OFFICIAL NOTICE OF DECISION

Project # PR-2022-007999
Plan #: [SP-2025-00091](#)
Site Plan – EPC, Major Amendment

TO: CABQ Development Facilitation Team (DFT)
FROM: Daniel Soriano, Planner
DATE: 01/28/2026
RE: PR-2022-007999/SP-2025-00091 – Major Amendment - Site Plan – EPC

SHEET: A1.1

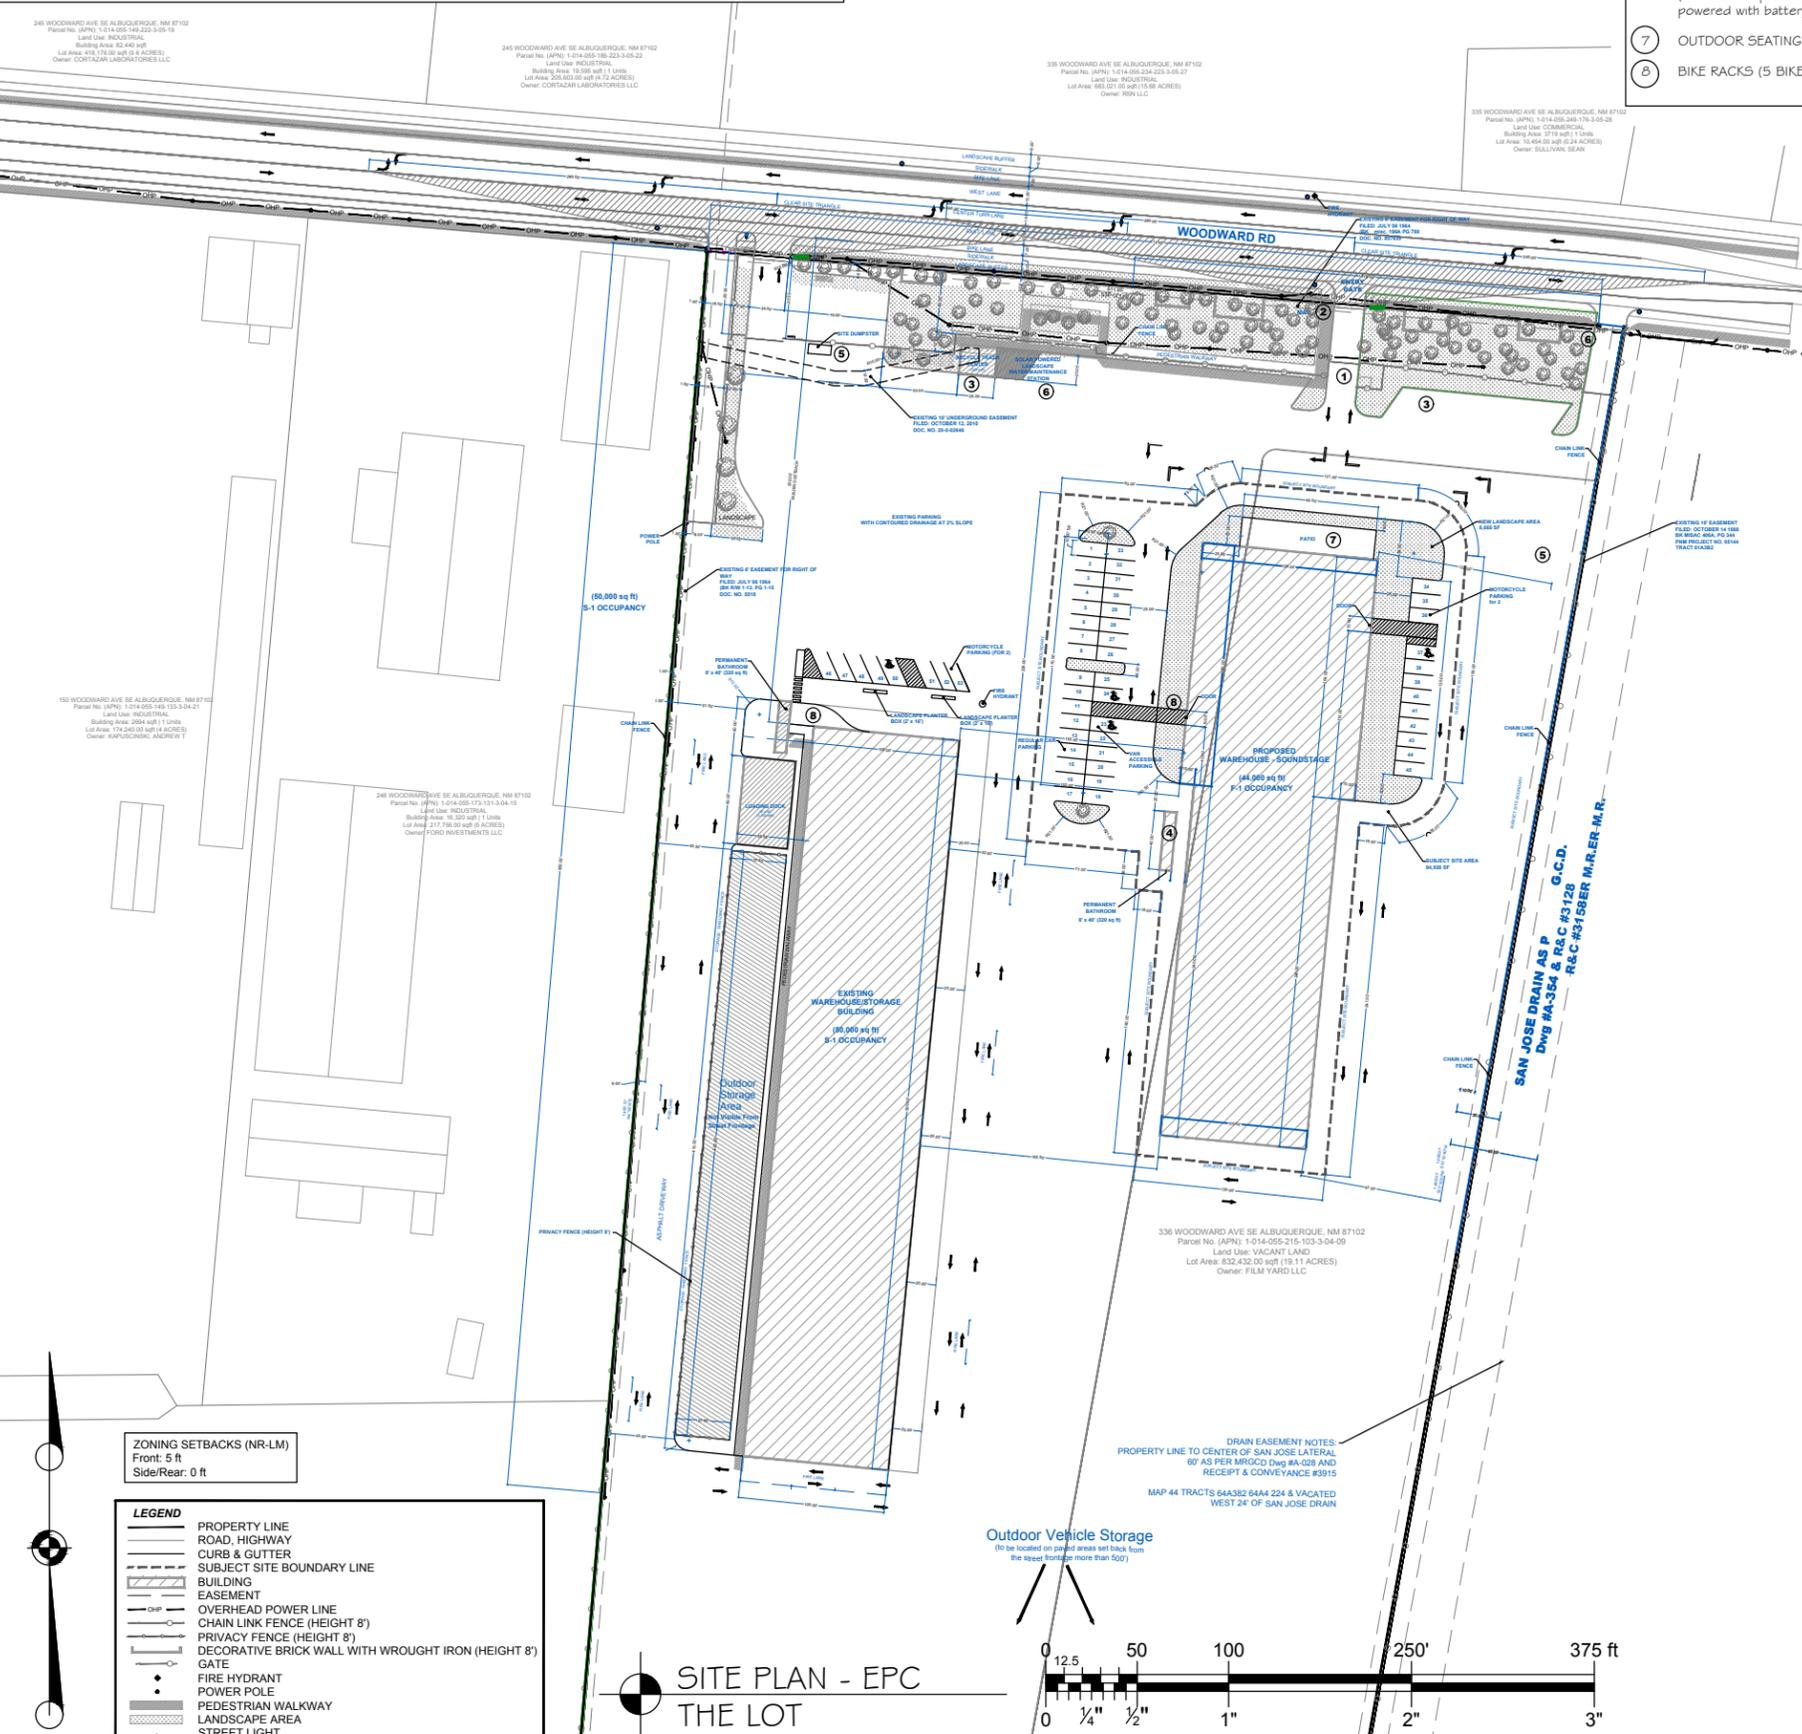
- 3. Site Plan clean up and revisions:
 - a. Update all sheets (site plan, landscaping, grading & drainage, TCL and utility) to accurately reflect form of developed phases on site, including both structures, new landscaping areas, new parking areas and outdoor storage areas.

- b. All existing and planned outdoor storage areas shall be listed on the Site Plan.
 - 1. Any fences and screening of these outdoor storage areas should be included on site plan and detail sheet.

- c. All existing outdoor storage areas on lots 64A4 and 224 shall be called out on Site Plan.
- d. Outdoor Vehicle Storage shall be added to the list of allowable uses on the site plan.
 1. All existing outdoor vehicle storage areas shall be called out on the site plan, including those stored on the site for loading/unloading and film production purposes.
- e. Parking calculations shall be updated to show total parking spaces required and provided on subject area.
 1. Update bicycle parking calculations to reflect how many bike spaces per bike rack are provided and the total amount of individual bicycle spaces on the subject area.

Condition 3a has been met by the applicant: The applicant has provided an updated Site Plan set that accurately reflects the site, including proposed and existing structures, new landscaped areas, parking and outdoor storage areas.

Condition 3b has been met by the applicant: The applicant has provided an updated Site Plan that shows the location of existing and planned outdoor storage areas, including any fences, walls and screening materials surrounding outdoor storage areas on the site plan and detail sheet.

Condition 3c has been met by the applicant: The applicant has provided an updated Site Plan that shows the land use of lots 64A4 and 224.

Condition 3d has been met by the applicant: The applicant has provided an updated Site Plan that includes Outdoor Vehicle Storage as a land use and has showed that Outdoor Vehicle Storage will be limited to the southern portion of the subject site.

Condition 3e has been met by the applicant: The applicant has provided an updated Site Plan that accurately reflects the required and provided parking calculations, including bicycle parking calculations and location on site.

Seal: Landscape Architect
STATE OF NEW MEXICO
DANNY D. MITCHELL
239
REGISTERED LANDSCAPE ARCHITECT
Nov. 21, 2024
Copyright 2024, Mitchell Associates Inc.
PROJECT NO. 2024-055
DRAWING NO. LS-101

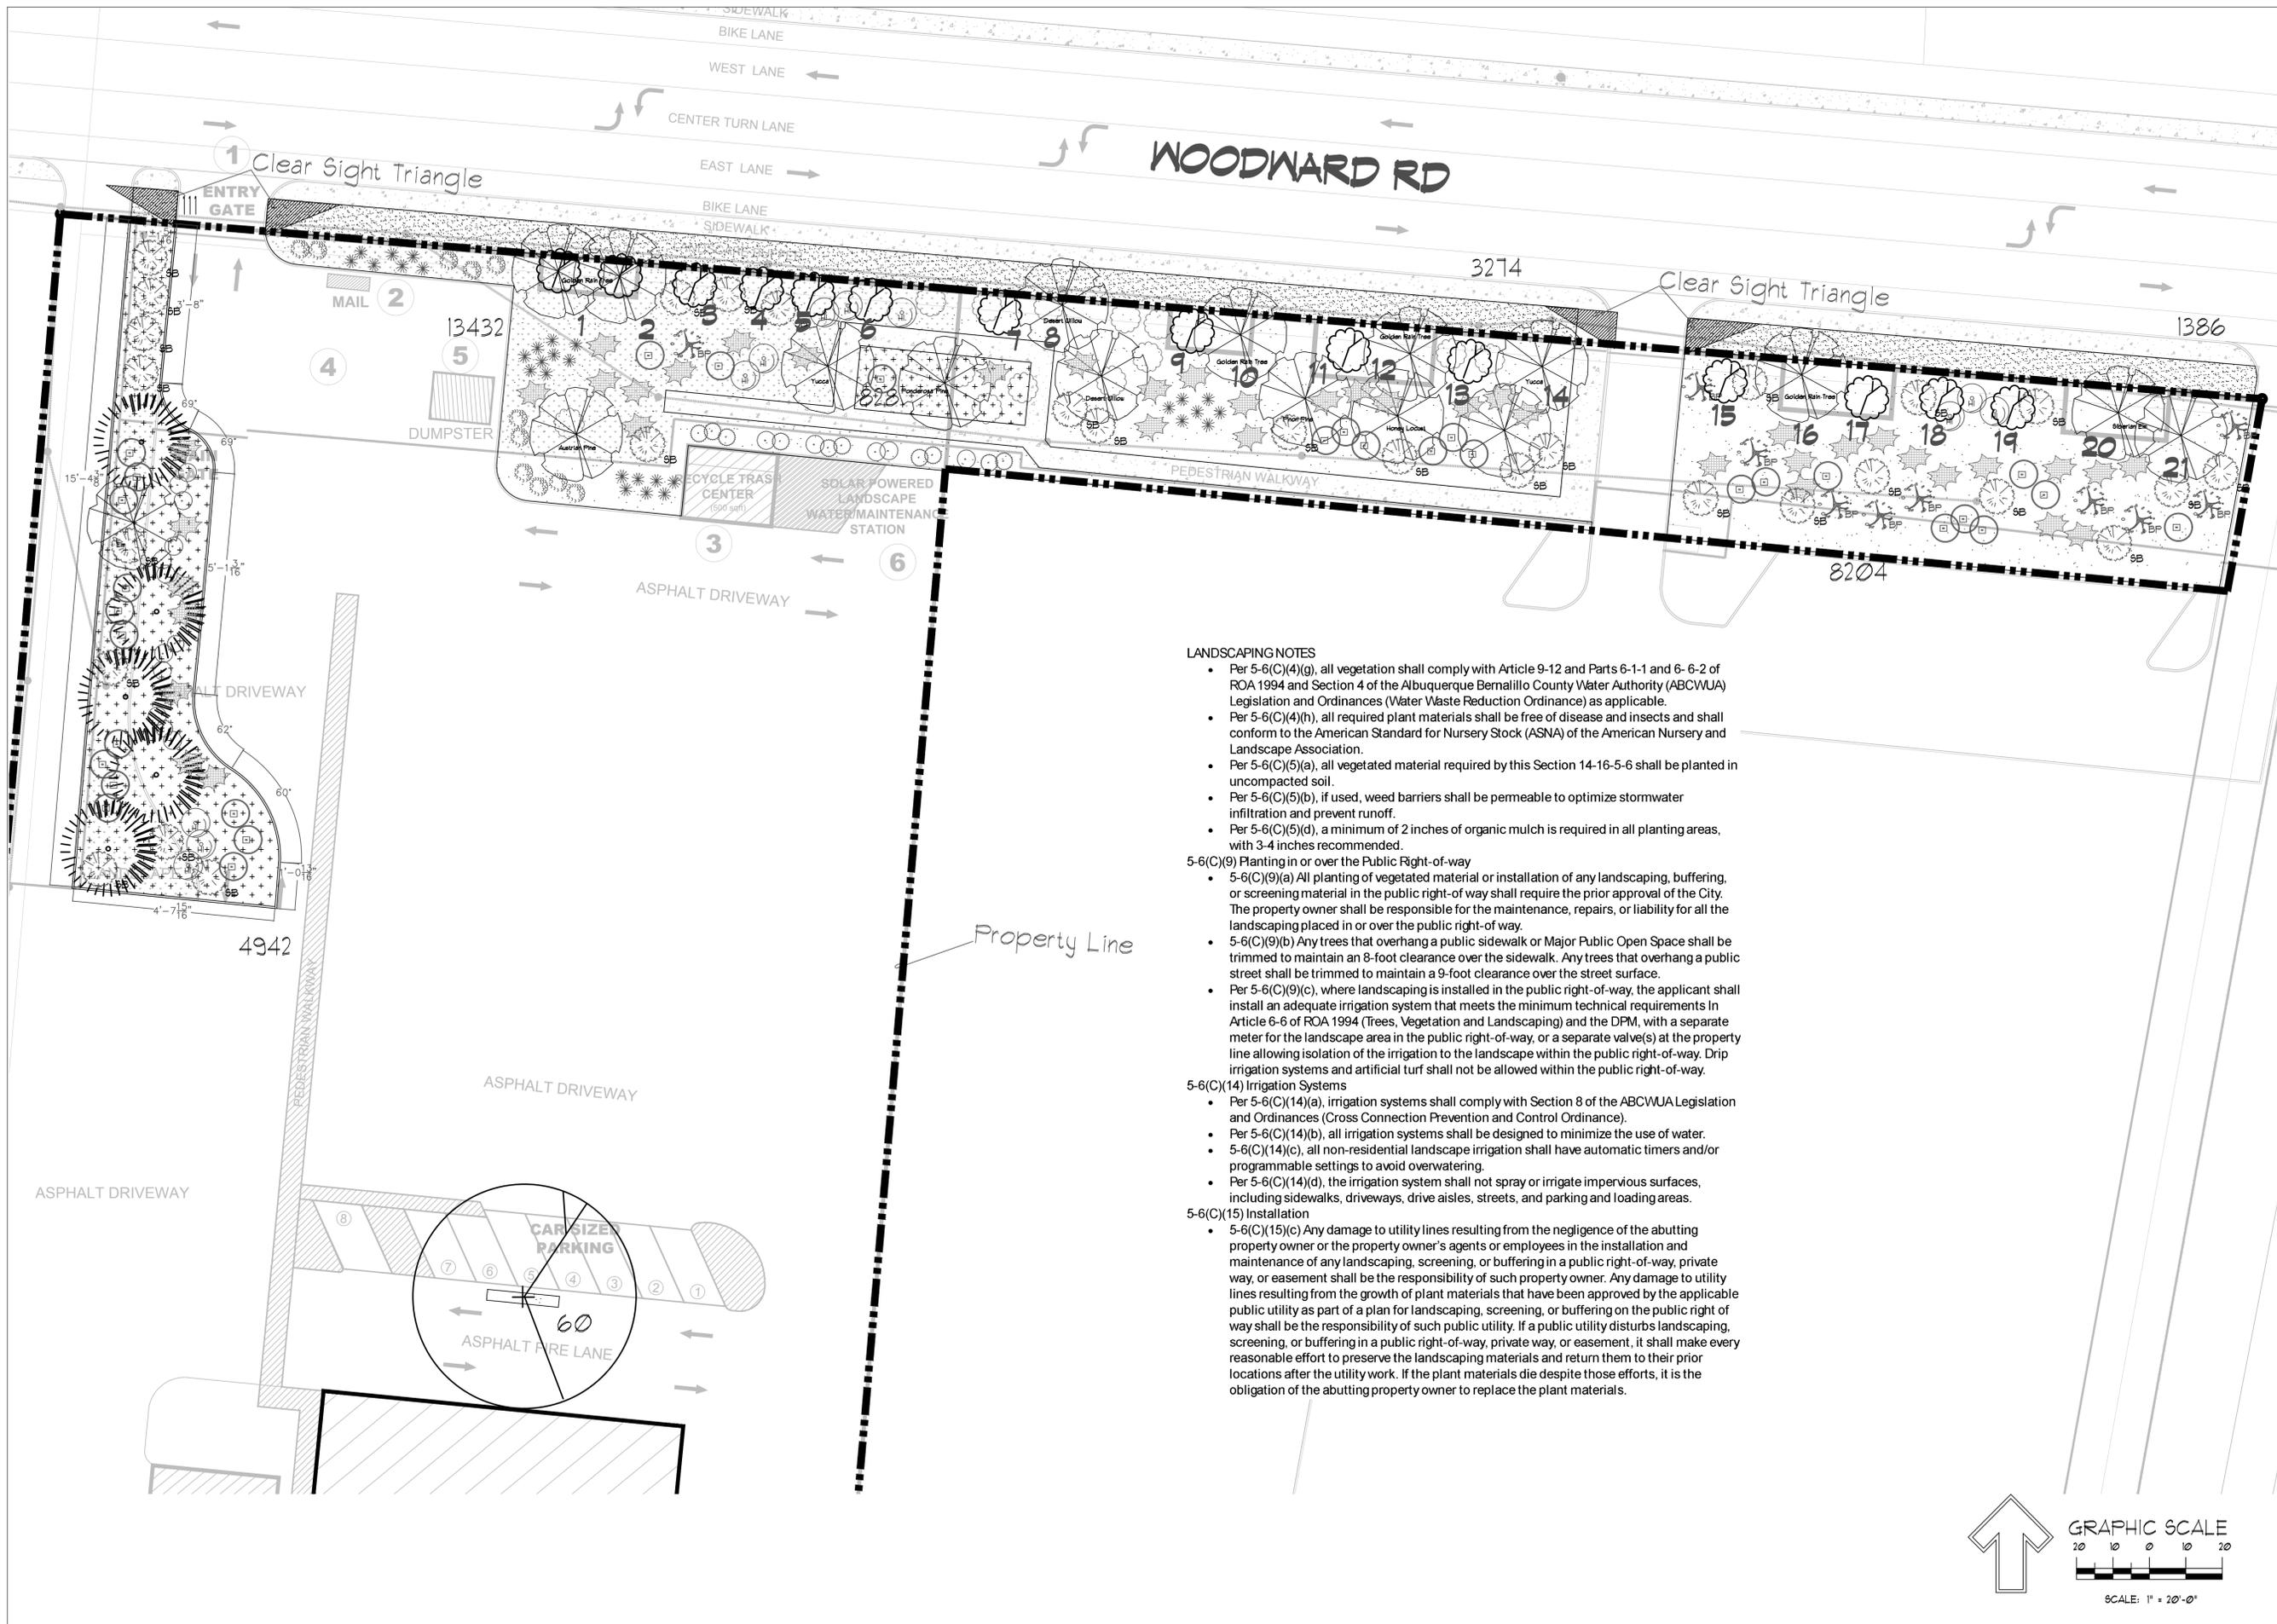
1. Landscaping sheet LS-101 shall remain the landscaping sheet for the current subject area of this request.
 - Update Total Tree and Total Shrub calculations to accurately reflect total amount of trees and shrubs that are on this sheet.
2. Re-name previous Landscaping sheet LS-101, which showed landscaping detail for lot 64A3B1 (PR-2022-007999/SI-2023-01621), to sheet LS-201.

Condition 6 has been met by the applicant: The applicant has provided updated Landscaping Plan/Sheets that accurately show the total landscaping calculations, landscaping provided, trees, shrubs for the subject area of Phases 1 and 2. The applicant has updated the landscape legend and re-titled sheets for consistency and clarity.

Landscape Plan (Overall)
Phase 1 and 2

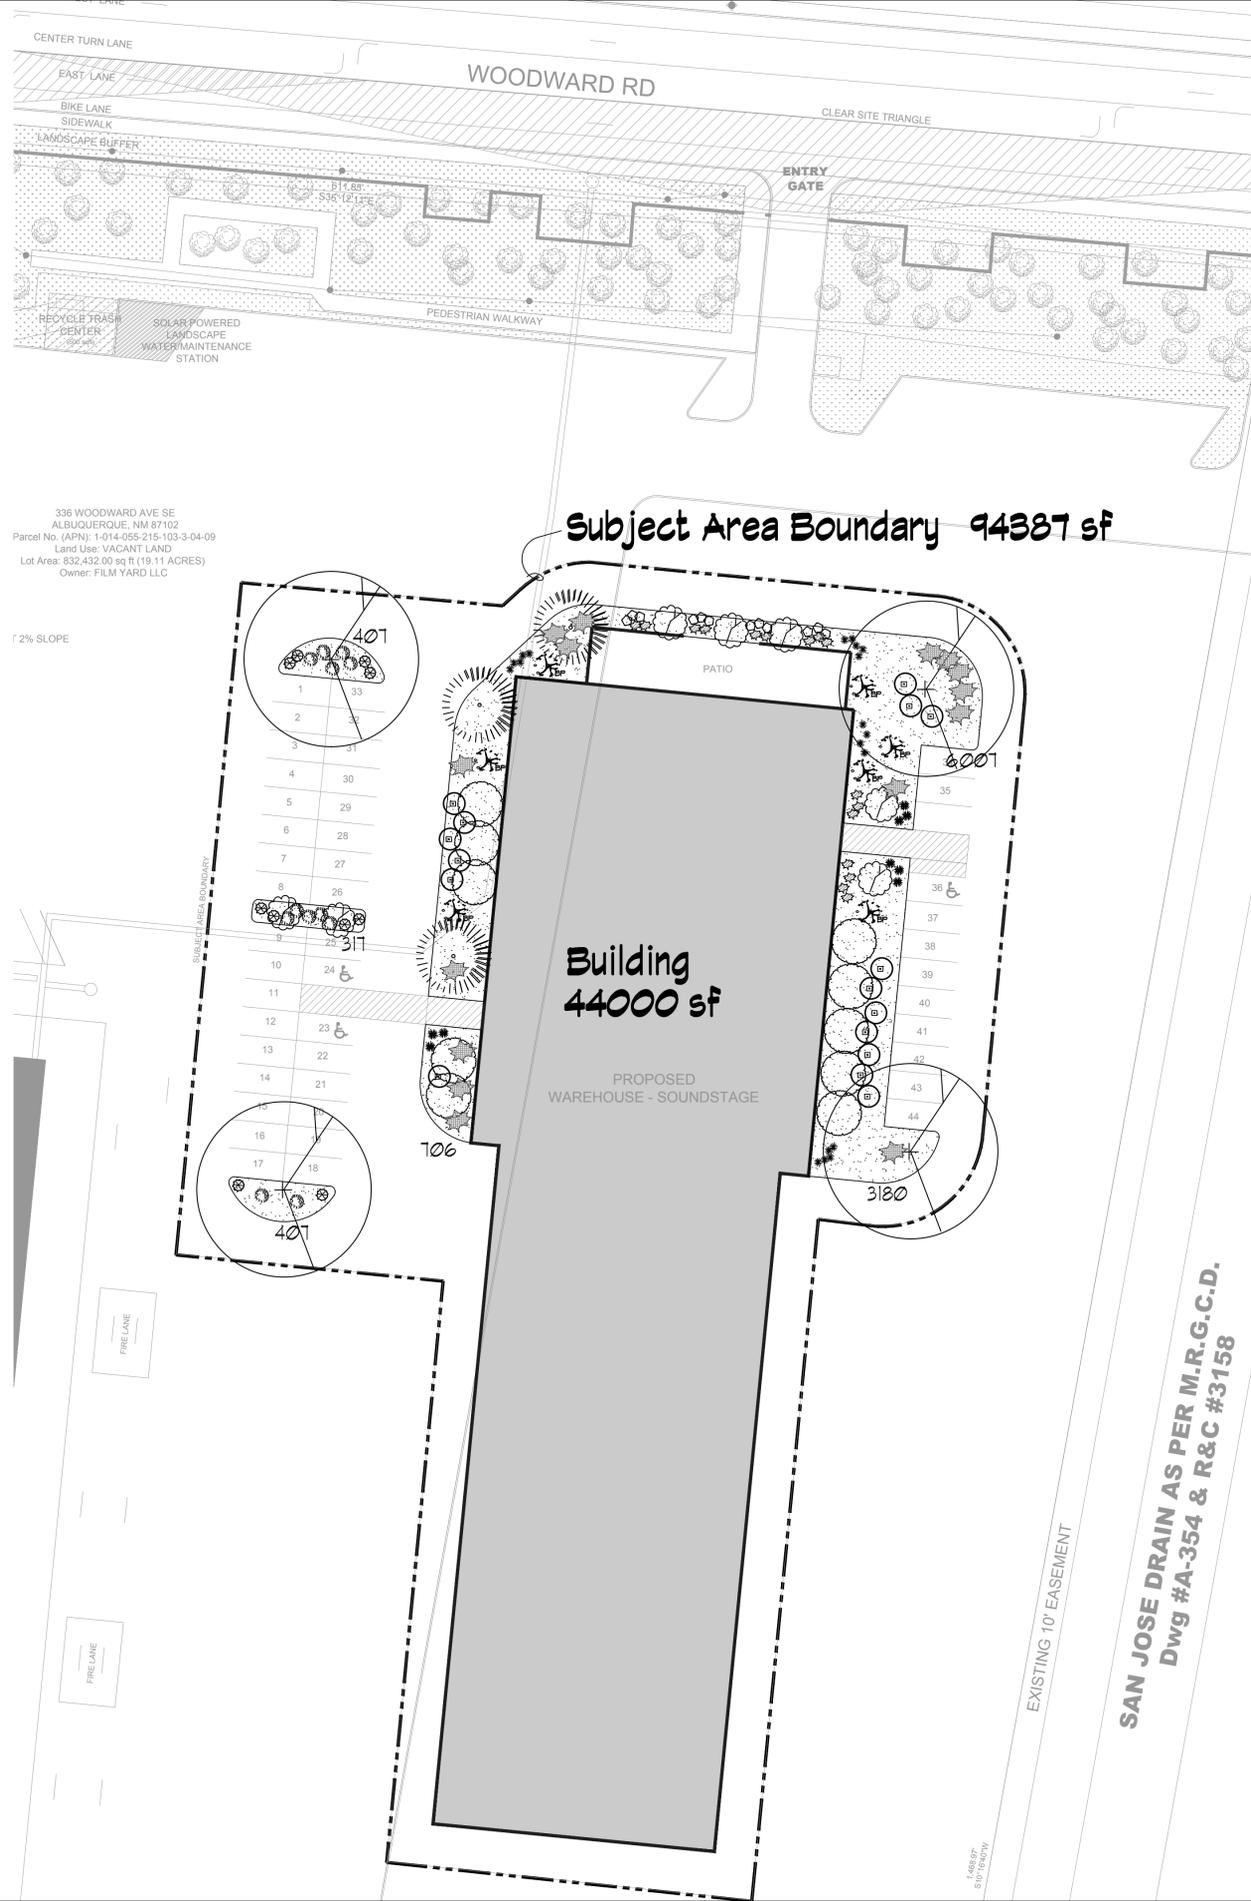
6. Landscaping Plan: Provide an additional, new overall Landscape Plan sheet (of both Phase 1 and 2) that shows the landscaping, calculations and landscape legend for the subject area.
